DOE-0170-06

**TRANSMITTAL OF THE ADDENDUM TO THE CERTIFICATION DESIGN LETTER  
AND CERTIFICATION PROJECT SPECIFIC PLAN FOR AREA 4B - PART ONE**

V/F: 20810-PSP-0008-08

V/F: 20810-PSP-0008-13

FIGURE 1. MAXIMUM EXTENT OF STORM WATER OVERFLOW IN CERTIFIED AREAS

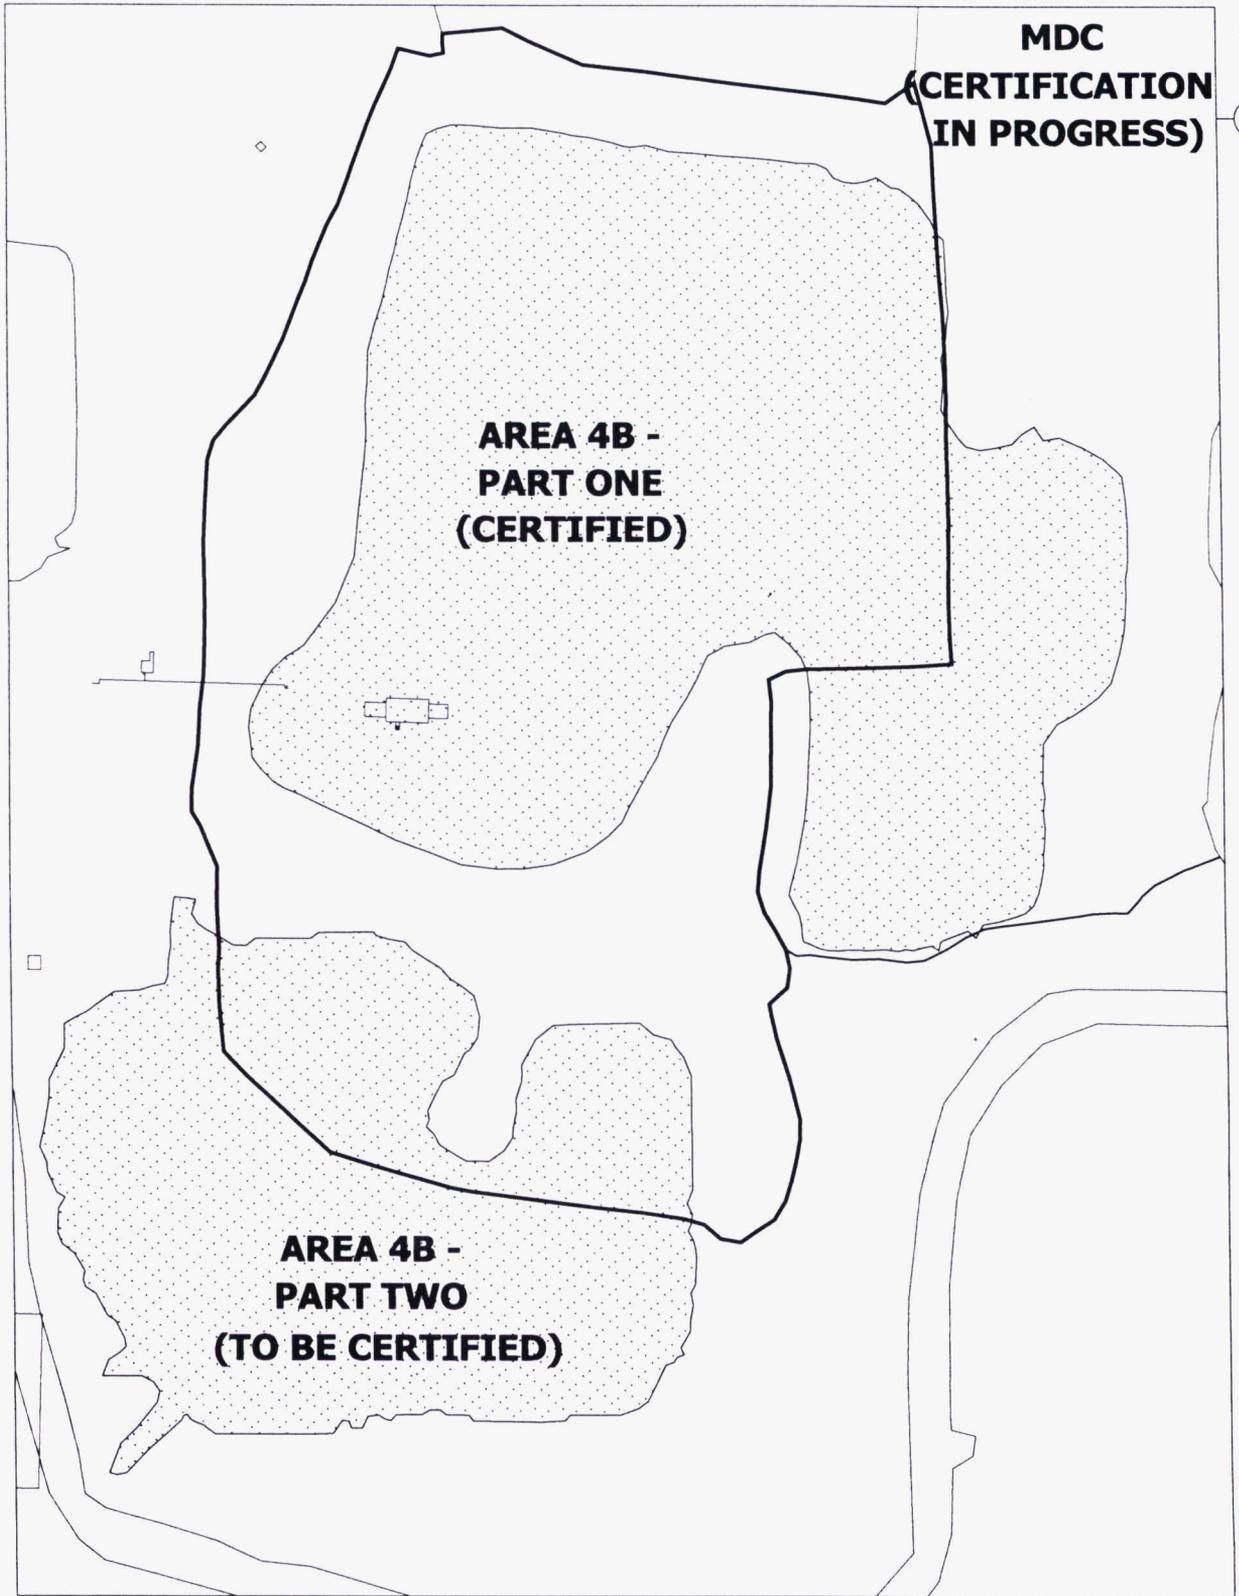
an extent that soil remediation in the certified area becomes necessary. The enclosed Figure 1 shows the maximum extent of storm water overflow in the area.

FIGURE 2. RE-CERTIFICATION SAMPLING LOCATIONS FOR CU A4B01

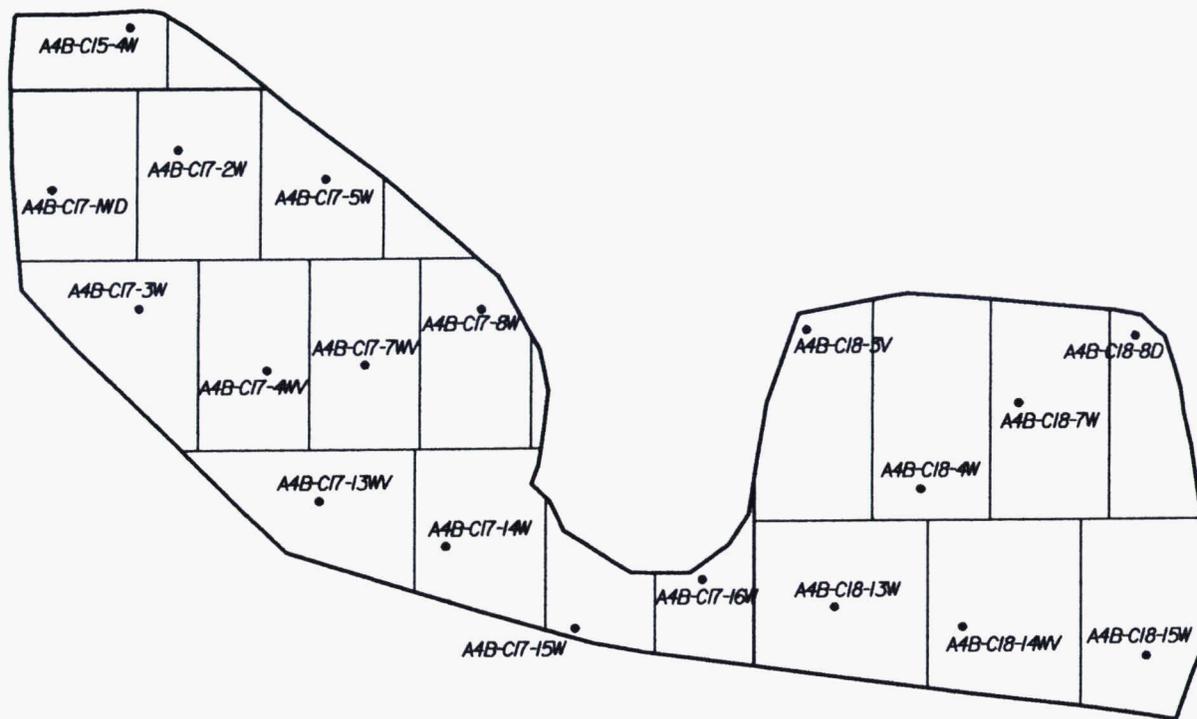
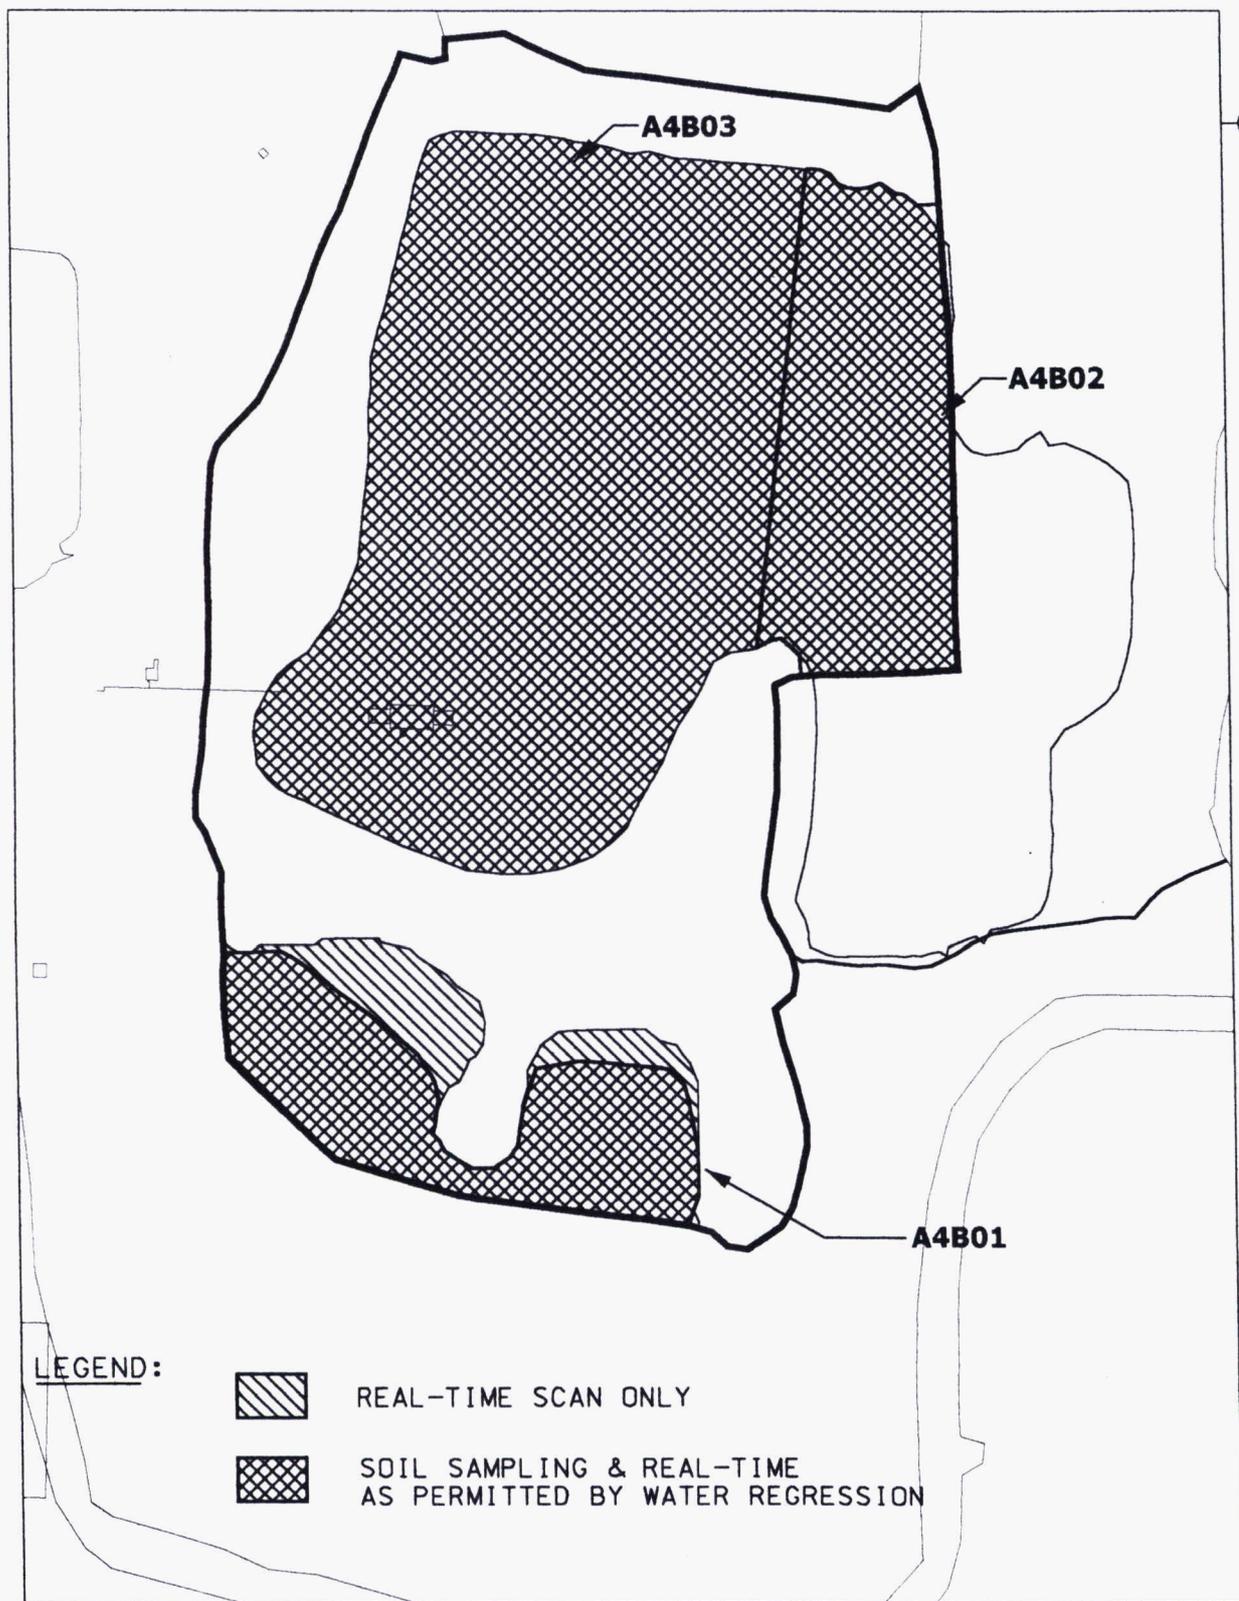
On May 10, 2006, samples were collected under Variance 20810-PSP-0008-07 from the southern end of previously certified Area 4B - Part One [certification unit (CU) A4B01] at the same locations of the original certification samples (see Figures 1 and 2). This CU is considered most likely to be recontaminated among all the areas due to the relatively higher concentrations of contaminants detected in the surface water in Area 4B - Part Two, which is immediately south of Area 4B - Part One. Additionally, this area has been drained, and the normal soil sampling procedure could be followed to access the extent of potential impacts in Area 4B - Part One by water crossing the certification boundary from Area 4B - Part Two. No significant changes in residual area-specific constituent of concern (ASCOC) concentrations were detected at most locations. All sample results from this sampling effort were below-final remediation level (FRL), with the exception of one location (A4B-C17-14W), which was 63 milligrams per kilogram for total uranium. This location is at the downgradient edge of the CU adjacent to Area 4B - Part Two (see Figure 2) and will be excavated to remove the contamination.

FIGURE 1. MAXIMUM EXTENT OF STORM WATER OVERFLOW IN CERTIFIED AREAS

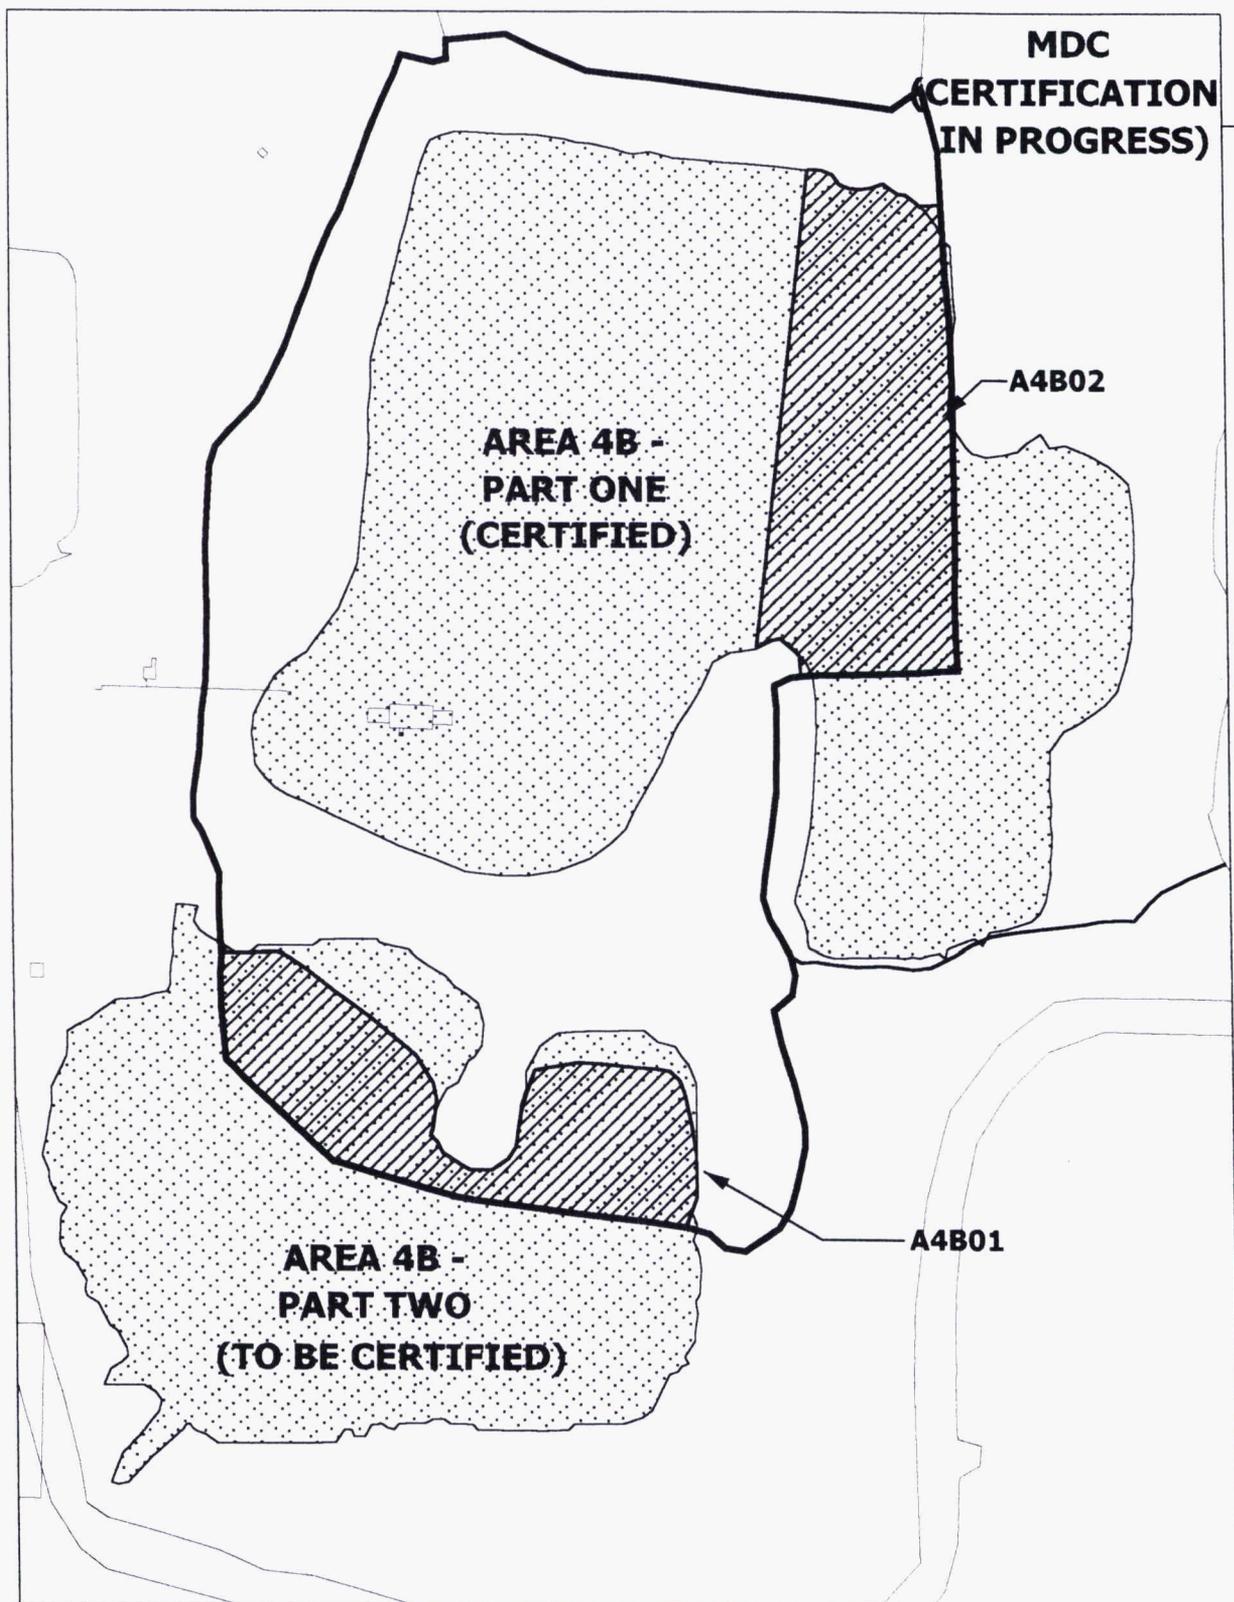
This Variance/Field Change Notice (V/FCN) documents the addition of one certification unit (CU), consisting of 15 soil sampling locations. These samples are being collected because potentially contaminated storm water runoff from the southern end of the Main Drainage Corridor breached the run-on control berms and ditches of the certified area (see Figure 1). The CU overlaps portions of previously sampled locations that were part of two former CUs from the original Area 4B – Part One certification effort (see Figure 2). Re-certification samples shall be collected and analyzed for radium-226, radium-228, thorium-228, thorium-232, total uranium, and technetium-99 (TAL A); beryllium (TAL B); and aroclor-1254.

FIGURE 2. RE-CERTIFICATION SAMPLING LOCATIONS FOR CU A4B02

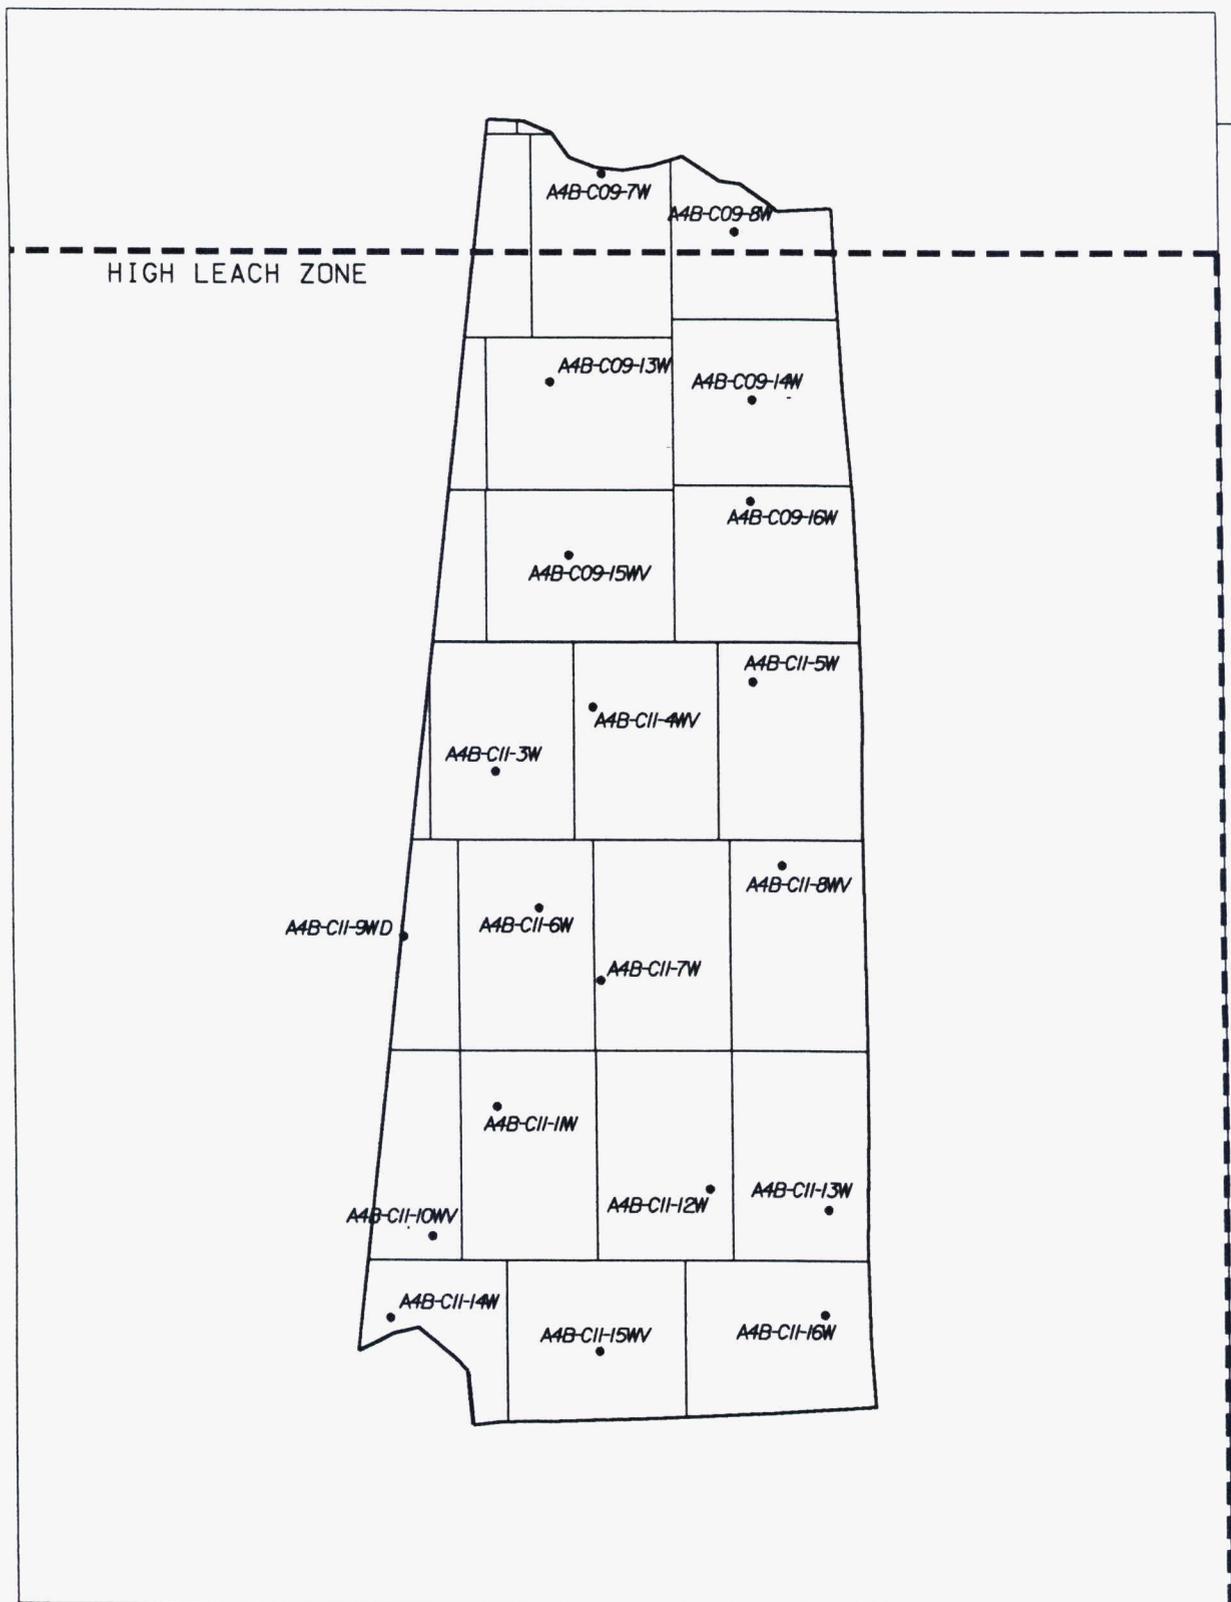
The purpose of this Re-Certification effort is to demonstrate that soil in Area 4B – Part One has not been impacted from water crossing the certification boundary from southern end of the Main Drainage Corridor and that ASCOCs still meet the risk-based FRLs. The new certification unit has been designed to cover a swath of the previously certified area along the certification area breach line. This swath represents worst-case conditions of potential contamination for the area that has been inundated with water, as the particulate contamination would have settled closest to the breach line. The certification sample locations that fall within the new CU match the locations of the previous certification effort. The data collected under this V/FCN will be compared to the data collected under the original certification effort from these locations. If the CU fails certification for any constituent, then this re-certification effort will be re-evaluated and additional sampling will occur. Per Section 4.3 of the PSP, the changes to the PSP will be documented with a V/FCN.
